Staff Report Number: CSOPS.24.018

125 Peel Street South Servicing
Public Information Centre Follow-up
Bill Abbotts

PEEL ST. SOUTH ALTERNATIVE NO. 2: FULL URBANIZATION

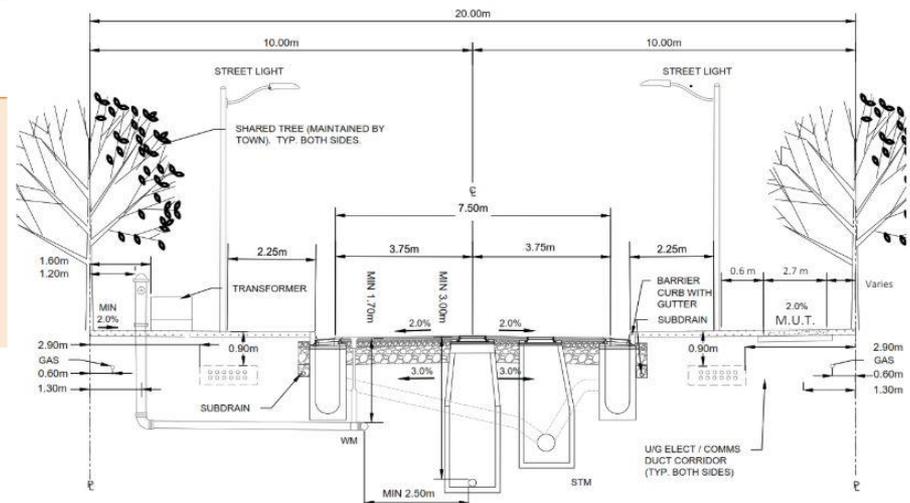
I maintain the “aligns” assumptions are severely flawed.

First, the Transportation Master Plan, of which I was a committee member, does not promote Multi Use Trails in urban settings. The brief mention of separated Multi Use Trails were meant for higher speed, higher volume roads **without** multiple driveways and high volumes of pedestrians. Bicycles especially heavy e-bikes ridden by novice riders are extremely dangerous when combined with pedestrian traffic, especially seniors with mobility devices. OTM Book 18 backs this up.

I am not able to find any information on the *Active Transportation Study*?

The proposed MUT on Peel St N is a dangerous mistake just waiting for accidents to happen if it is constructed as proposed! It is not a safe nor pedestrian friendly town standard, nor should it be in urban areas! Pedestrian cycle (especially e-bike, cargo bikes, and bikes with trailers) conflicts will happen on the 2.7 metre MUT.

Cyclists motor vehicle incidents will occur on the narrow roadway with barrier curbs. Please do not keep repeating this dangerous mistake.

Louisa St

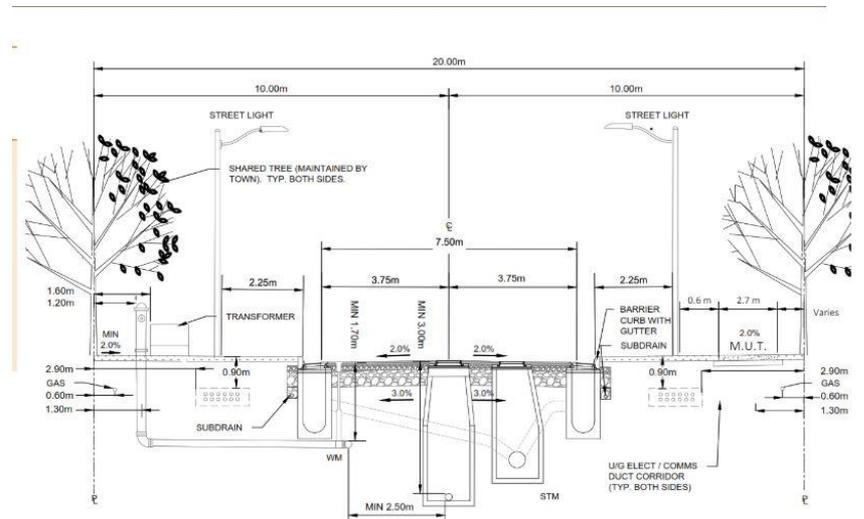
This is a photo of the recently reconstructed Louisa St west of Elma St S. After much discussion with a 2nd previous council and TBM staff of the time, all Thornbury West will be this profile. It is more of a standard than the MUT profile.

The vehicle lanes are 3 metres and the “fog lines” for active transportation are at 1.25 metres. Pavement width of 8.5 metres.

There is a 1.5 m sidewalk on one side.

The curbs are semi mountable for cyclists safety.

Louisa travel width requirements 10 metres – 3 metre vehicle, 1.25 metre paved shoulder, semi mountable curbs, 1.5 metre sidewalk = 10 metres

Proposed Peel St travel width requirements 10.2 metres – 3.75 metre vehicle, barrier curbs, 2.7 metre MUT = 10.2 metres. Slightly more room for tree retention

Engineering Standards

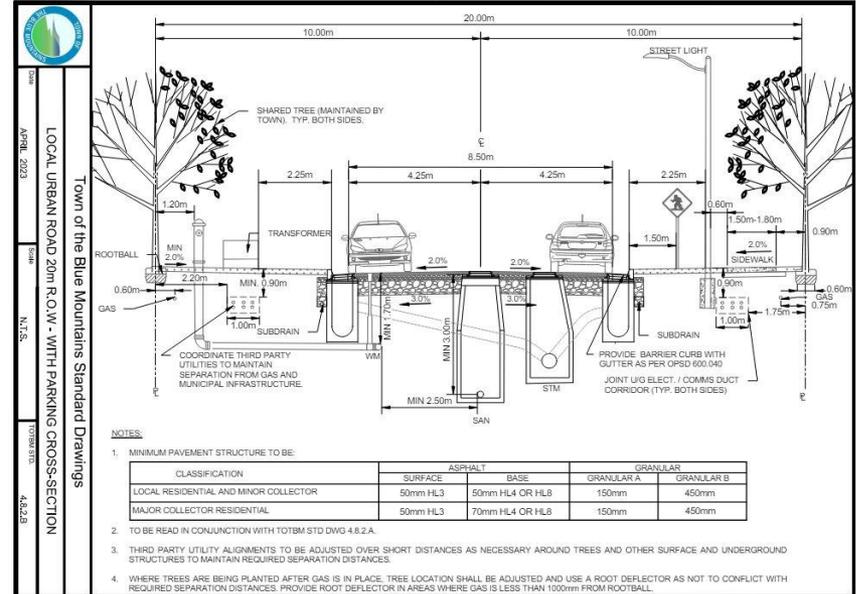
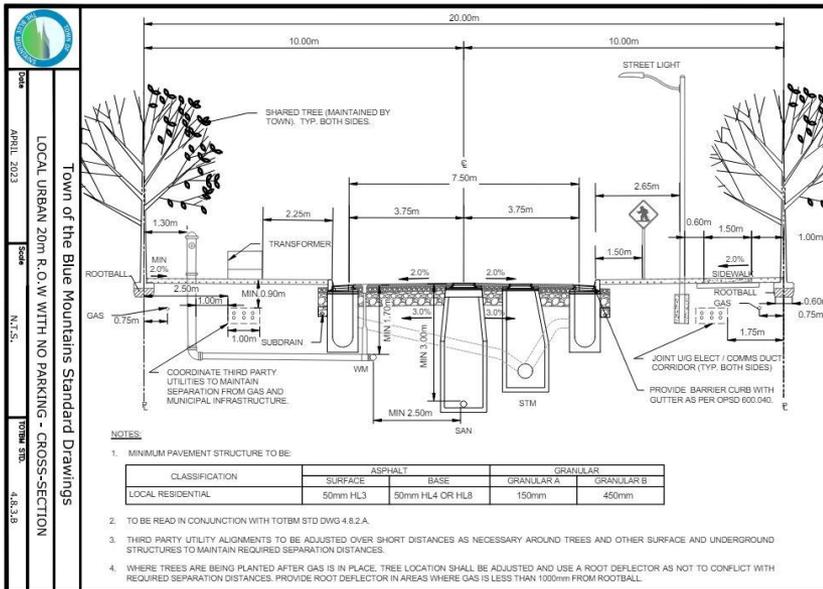
Both that I could find have a 1.5 metre sidewalk.
 Without parking pavement width of 7.5 metres –
 perfect for sharrows for cyclists.

Both that I could find have a 1.5 metre sidewalk.
 With parking pavement width of 8.5 metres – perfect
 for 3 metre vehicle lanes and 1.25 paved shoulders!
